# **Byron Unit 1 Extended Cycle 8 Report**

**ComEd**

**October 1996**

### **BYRON UNIT 1 RESPONSE TO**

Figure 30A

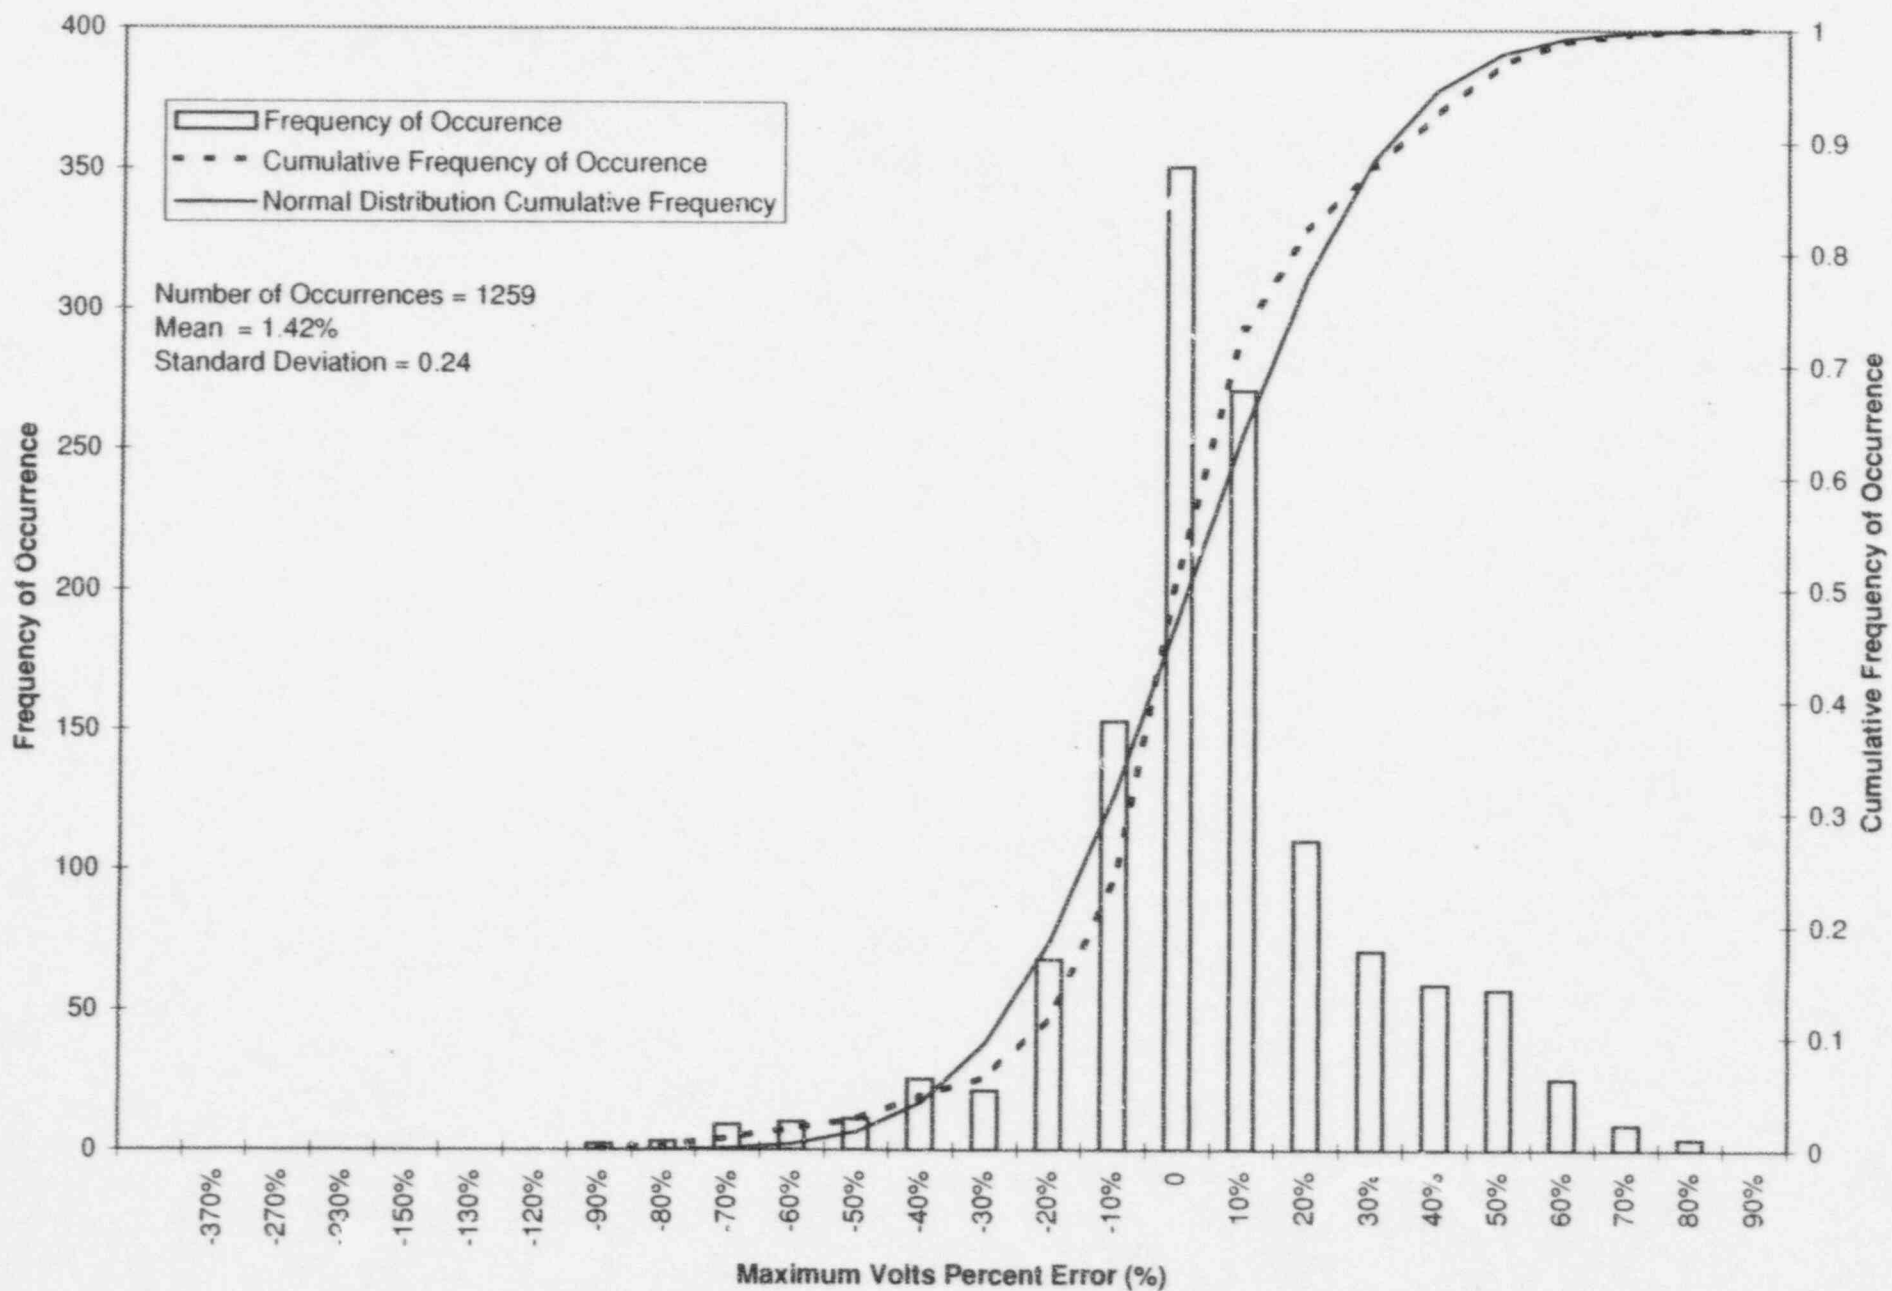
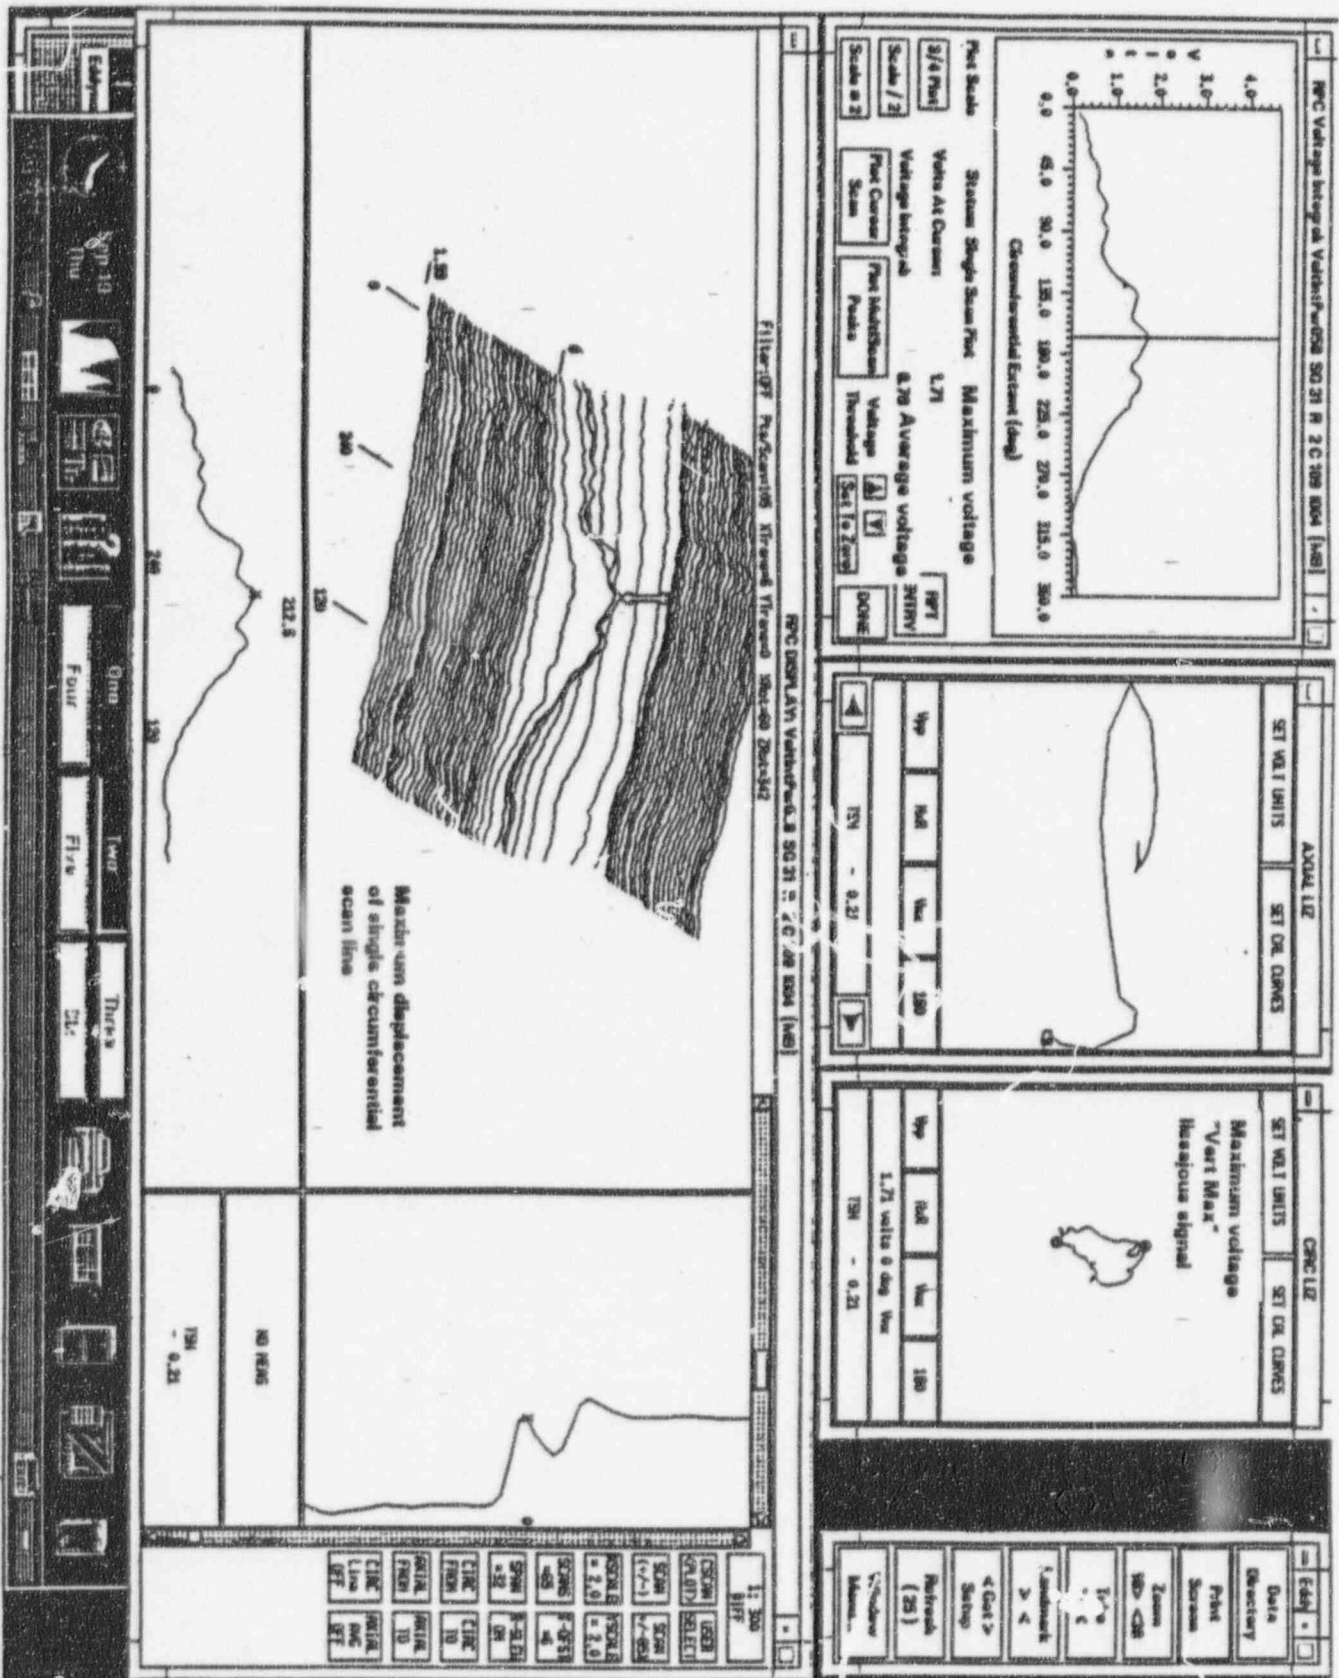
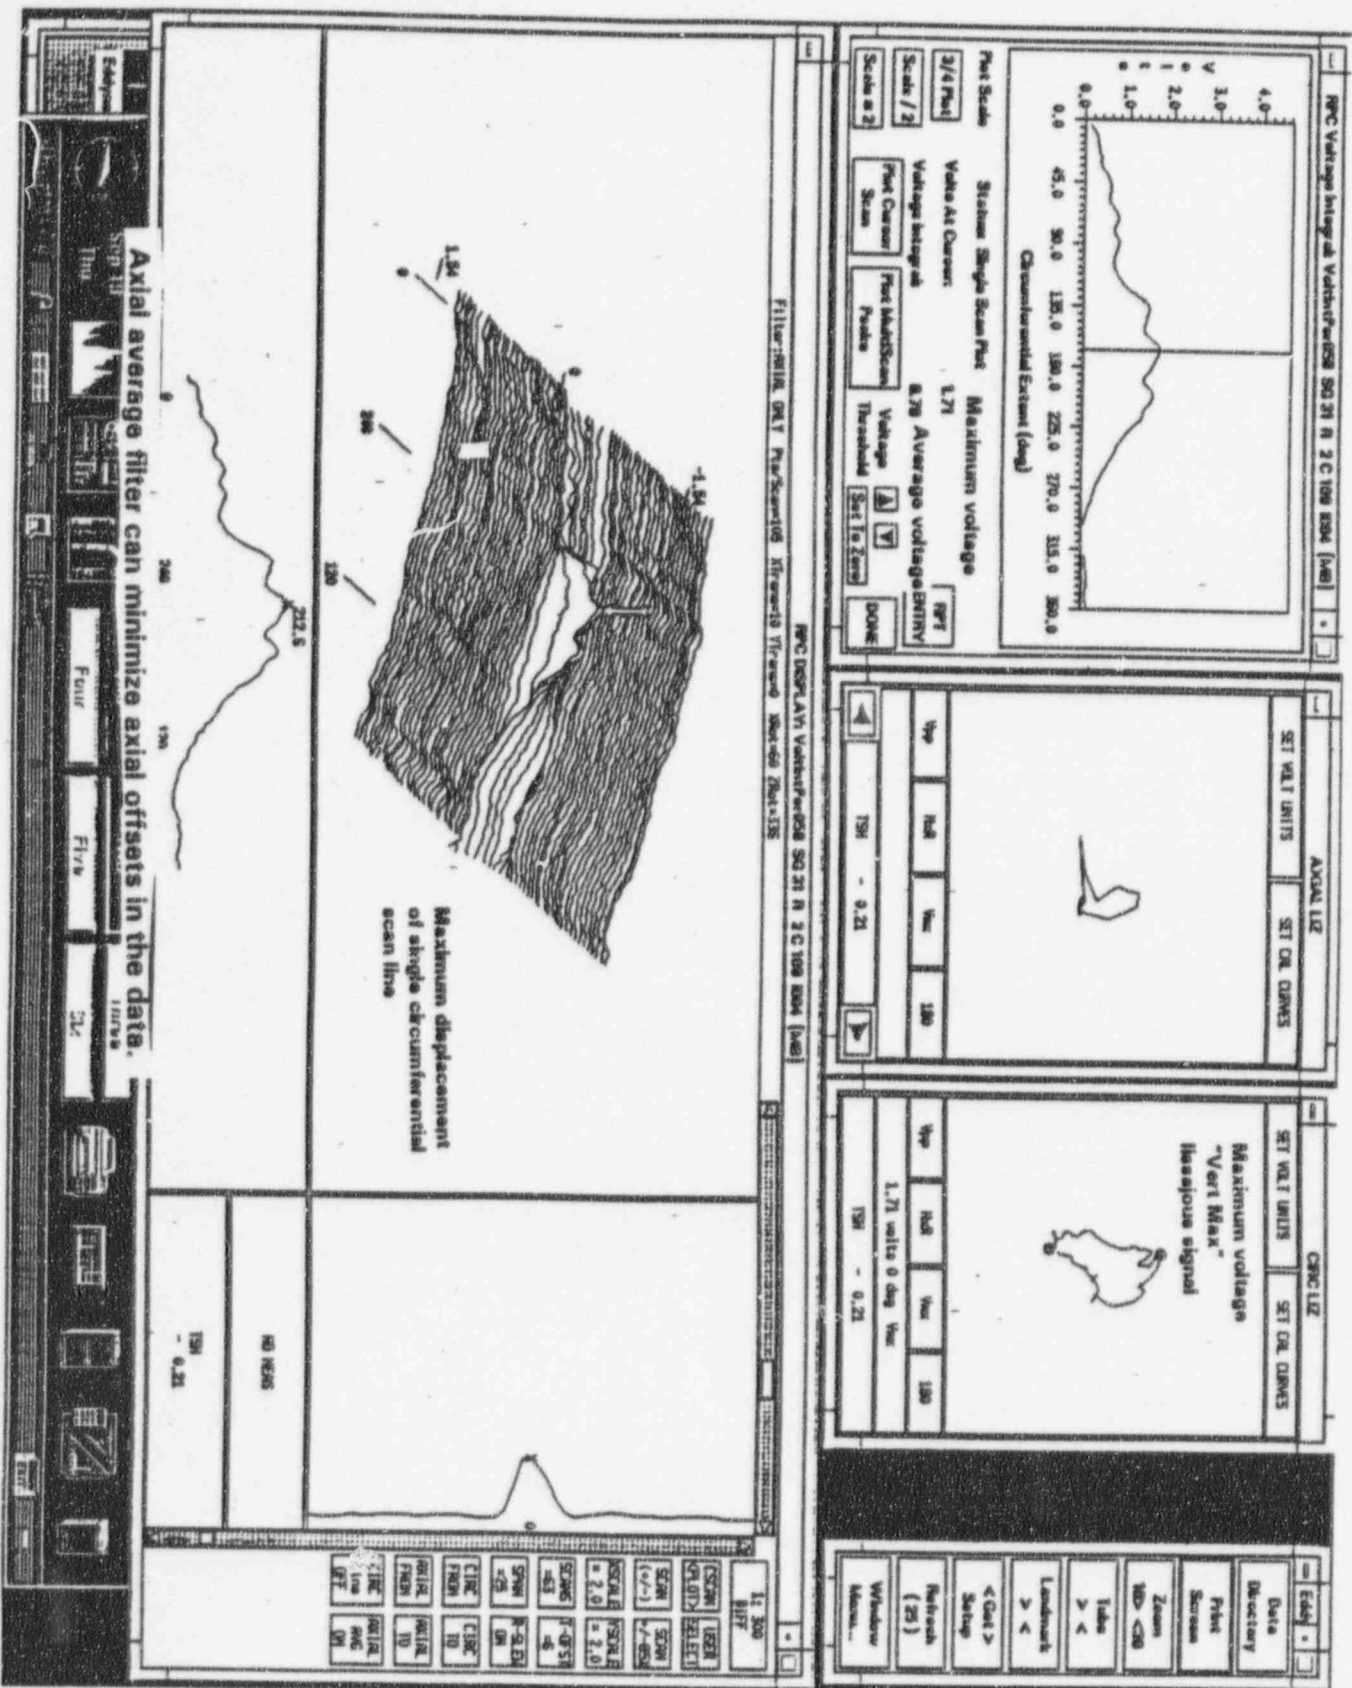
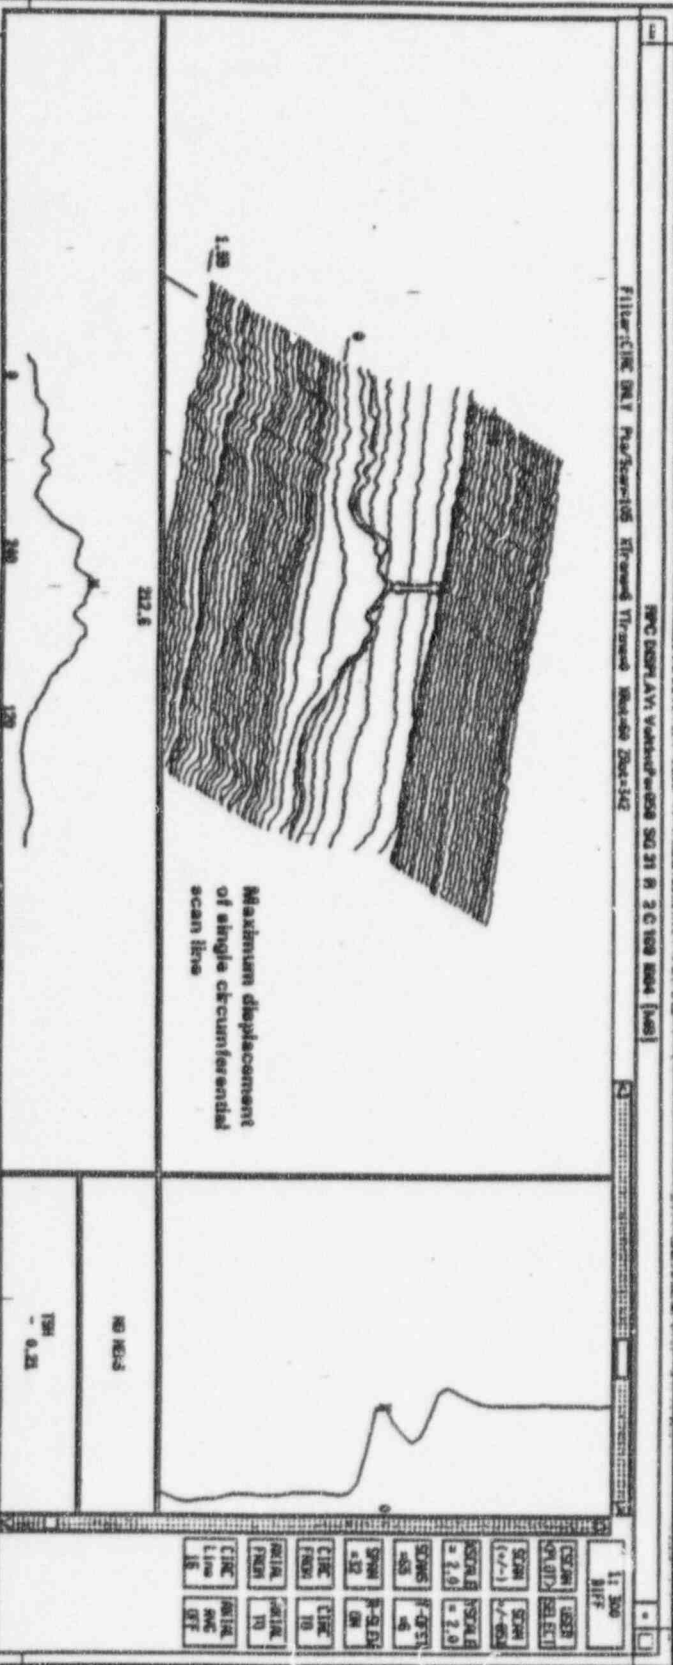
30. **Provide a copy of the EC sizing procedures used in the assessments of the analyst uncertainty, the growth rate, the burst and leakage data, and the POD. Discuss the extent of use and the influence of the following on any EC voltage measurements: (1) the use of Eddynet95 data filters; (2) the trigger offset feature and (3) the presence of 360m circumferential flaws. Address both the EC voltage integral and the EC maximum voltage measurements.**

To evaluate the impact of these filters and results, ComEd performed an evaluation on voltage measurements with the use of filters. Figure 30A represents voltage measurements for non-filtered data. Figure 30B represents voltage measurements with the use of the Axial Average filter. Figure 30C represents voltage measurements with the use of the Circ. Line filter. Figure 30D represents voltage measurements with the use of the Axial Average and Circ. Line filter.

- The maximum and average voltage does not change with an Axial Average filter.

- The maximum and average voltage does change with a Circ. Line filter. The resultant output of the voltage measurements is reduced. Selecting a non-degraded circ line to be used as a filter does not reduce the flaw signal.
- The maximum and average voltage remains the same as the Circ. Line filter, when using the Axial Average and Circ. Line filters in combination.

Therefore, ComEd analysis is correct because the use of filters does not affect the voltage signal corresponding to the flaw.
